Number	FF.1
Section	Automatic Transmission
Sheet	1 (of 1)
Date	May, 1960

TORQUE CONVERTER SETSCREWS

(All Automatic Transmission Models)

FIG 1

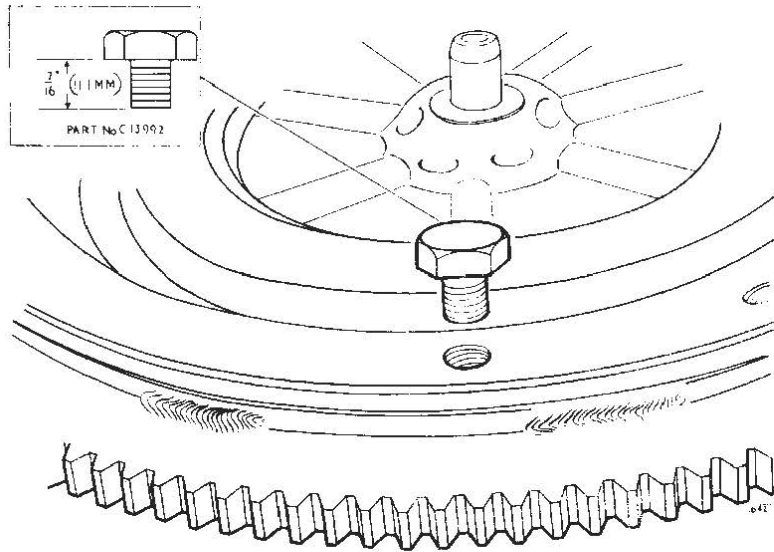
Note that it is ABSOLUTELY ESSENTIAL that the long setscrews which are $17/32"$ (13.5 mm) in length (see inset in Fig.2.) are not fitted to a torque converter which does not have cut-a-ways machined under the setscrew holes, otherwise the setscrews will bottom in the holes. A torque converter without the cut-a-way is illustrated in Fig.1; the $7/16"$ (11.1 mm) long setscrew which MUST be fitted to this type of converter is shown inset.

FIG 2

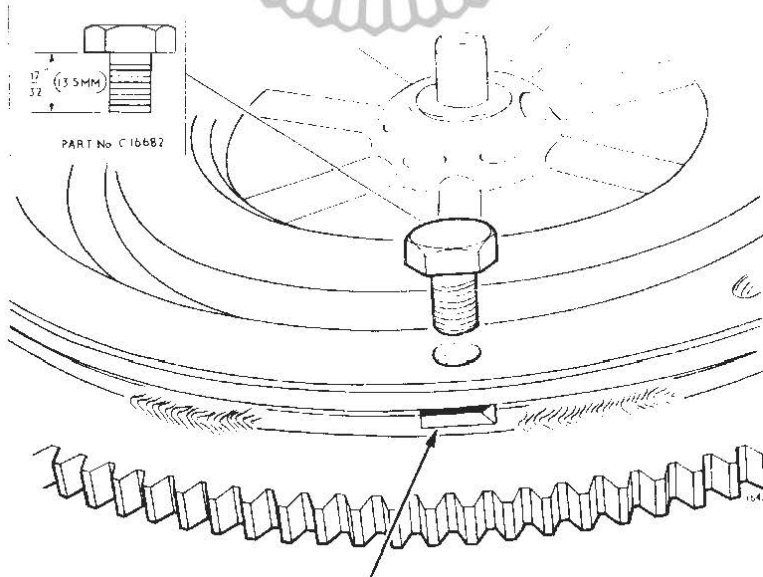
Torque converters are now secured to the drive plate with longer setscrews (Part number C.16682). To ensure full engagement of the longer thread, a cut-a-way is machined in the torque converter below each threaded hole as indicated by the arrow in Fig.2.
